Work Order ID 102938

Item Name: Crosstube Aft

DRAWING NO. D212-664-241	TITLE CROSSTUBE ASSY (205/212 HI AFT)	REV. D	DART AEROSPACE LTD ENGINEERING ORDER		D.E.O. NO. D212-664-241-D-1	SHEET NO. SHEET 1 OF 2	SCALE NTS
DRAWN	CHECKED		MFG. APPR.		APPROVED	DE APPR.	
DATE 11.04.07	DATE 11.04.11		DATE 11.04.12		DATE 11/04/12	DATE 11.04.12

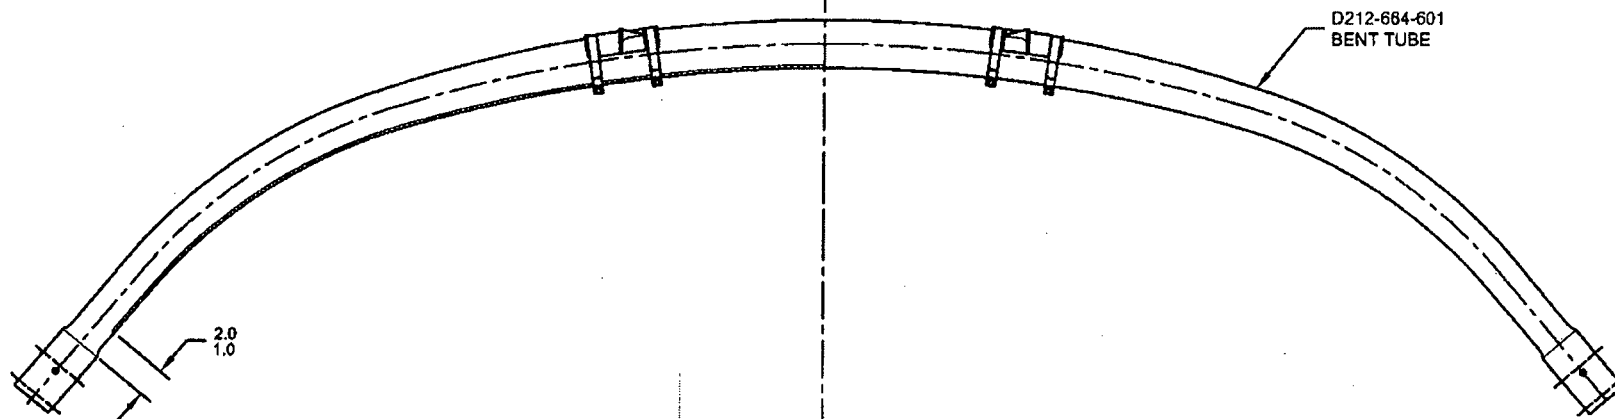
ADD AN INSPECTION WINDOW TO UNDERSIDE OF CROSSTUBE.

NOTES 2 OF SHEET 1 IS AMENDED AS FOLLOWS:

- 2) FINISH: CHEMICAL CONVERSION COAT PER DART QSI 005 4.1  
PRIME INSIDE AND OUTSIDE PER DART QSI 005 4.2  
MASK UNDERSIDE OF CROSSTUBE AS SHOWN (HATCHED AREA) AND  
PAINT OUTSIDE PER DART QSI 005 4.2  
REMOVE MASKING AND APPLY CLEAR COAT

**FIGURE 1: SUPPORT INSTALLATION**

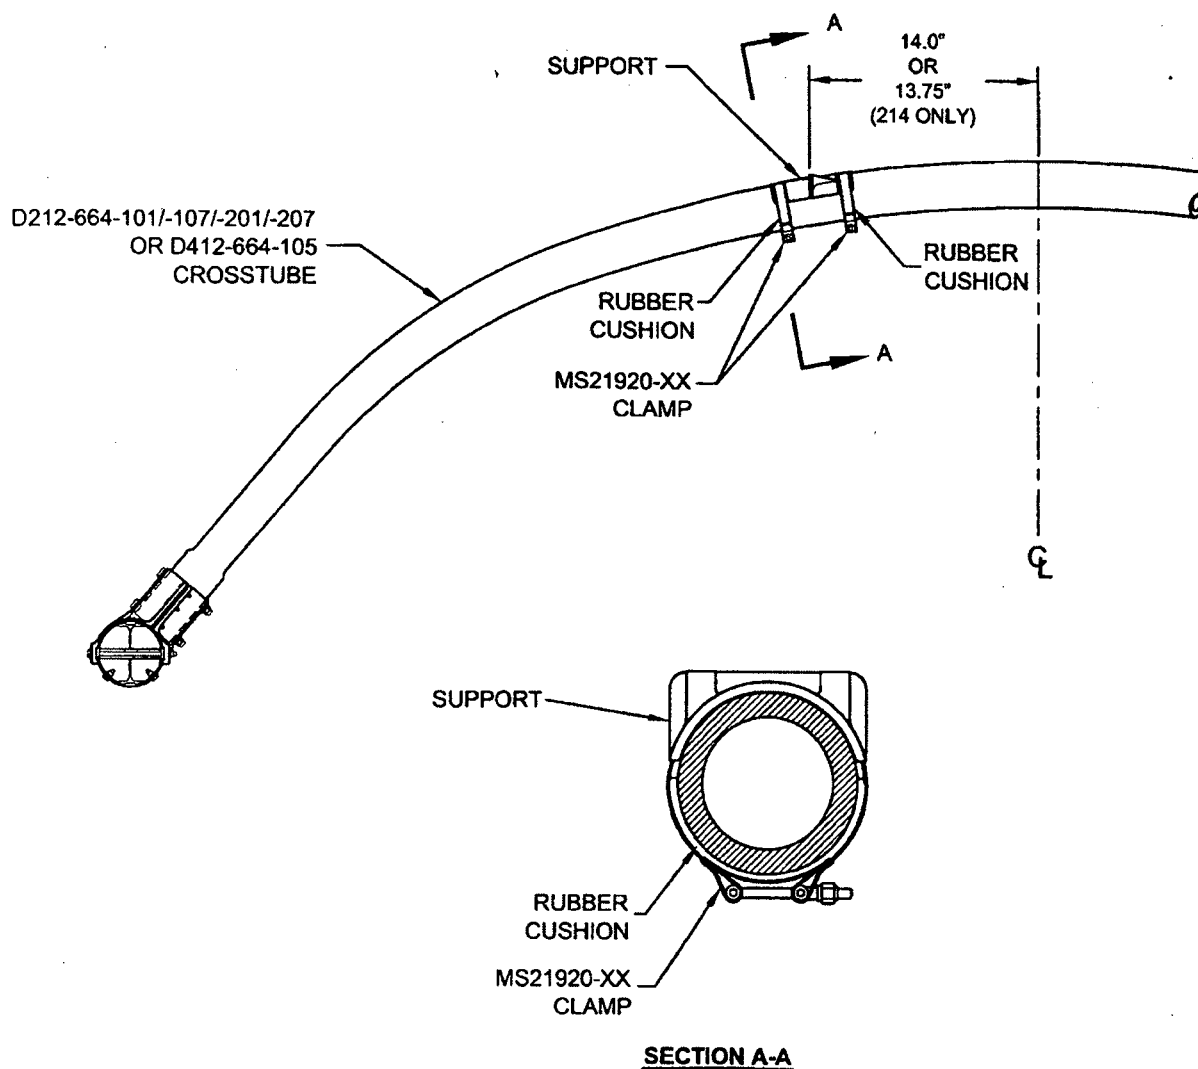
For the crosstubes listed above, section 32.4 of ICA-D212-664 is amended as follows. Use Figure 1 of this service instruction and Figures 32-2 to 32-9 of ICA-D212-664 for further reference. For crosstubes of an earlier change number, it is recommended that if the supports are removed, the supports should be reinstalled using the procedure listed below.

- 32.4.1 Locate the area on the crosstube for installation of support (see Figure 1 of this service instruction). For D212-664-101/-107/-201/-207 and D412-664-105 crosstubes, the outward face of the support tabs should be 14.0" (355mm) from the crosstube center for 204/205/210/412/UH-1 aircraft. For installation on 214B/B-1 aircraft, the outward face of the support tabs should be 13.75" (349mm). Ensure paint finish of crosstube is intact; touch up as required per Chapter 5 (5.3.9) of ICA-D212-664.

- 32.4.2 If present, remove any paint/primer on bottom of supports. Abrade mating surfaces of support and crosstube with 400-grit sandpaper. Saturate a clean cloth with MEK or 4105S Wash'n'Wipe Degreaser or equivalent and wipe until there is no residue.

- 32.4.5 Apply a 0.04" to 0.07" thick layer of Proseal 890 Class B or AMS-S-8802 Class B sealant underneath applicable support and install support as shown in Figure 1 of this service instruction.

- 32.4.6 Install the clamps opposite to crosstube support as shown in section A-A of Figure 1. Install rubber cushions underneath each clamp around the bottom circumference of the crosstube up to the crosstube centerline. Torque clamps 80-100 in-lb (9.0-11.3 Nm). It is acceptable to use smaller or larger sized MS21920-XX clamps than those listed in ICA-D212-664, ensure that after torquing the clamps per this instruction, the nuts are in safety but not bottomed out
